III. Responses to Comments

A. Introduction

C. Comment Letters

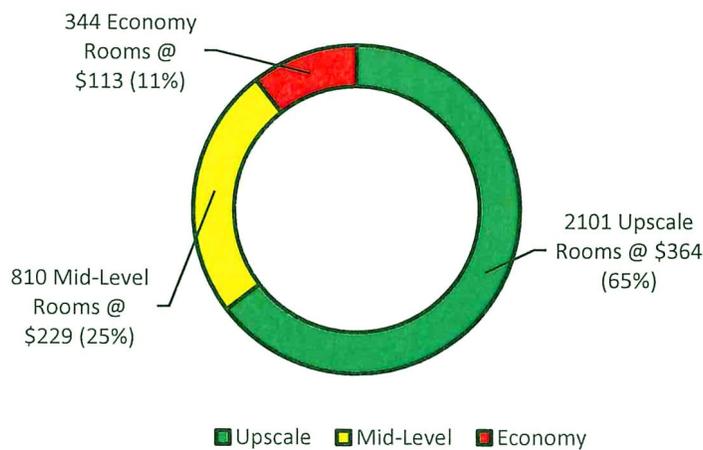
Comment No. 7-15

According to recently published data from the Downtown Long Beach Alliance,⁸ Downtown Long Beach contains a total 3,255 hotel rooms, of which 2,101 rooms or 65 percent are upscale at an average rate of \$364; 810 rooms (25 percent) are mid-level at an average rate of \$229; and a mere 344 rooms (11 percent) are economy at an average rate of \$113 (as reflected in the table and chart on the following page).

Figure 4: 2014 Statewide All Fleet Sizes (Pieces of Equipment)

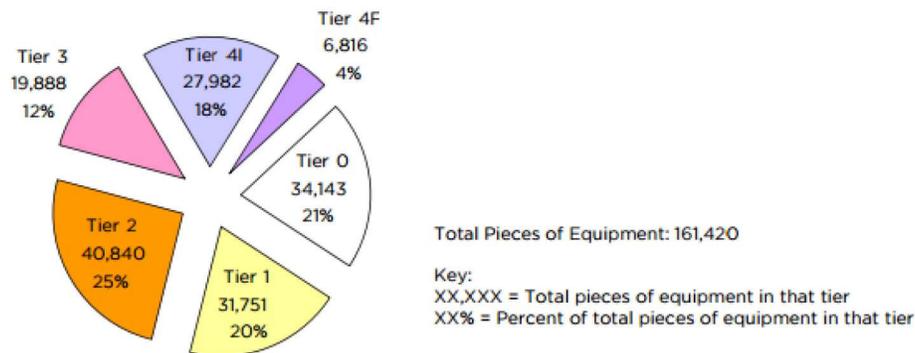
Furthermore, review of the DEIR demonstrates that the DEIR failed to evaluate the feasibility in obtaining Tier 4 equipment. Due to the limited number of Tier 4, especially Tier 4 Final, equipment available, the DEIR should have assessed the feasibility in obtaining equipment with Tier 4 Final (or interim) engines (see excerpt below).¹⁰

As demonstrated in the figure above, the Tier 4 Final and Interim equipment only account for 4% and 18%, respectively, of all off-road equipment currently available in California. Thus, emissions are modeled assuming that the Project will be able to obtain 9 pieces of
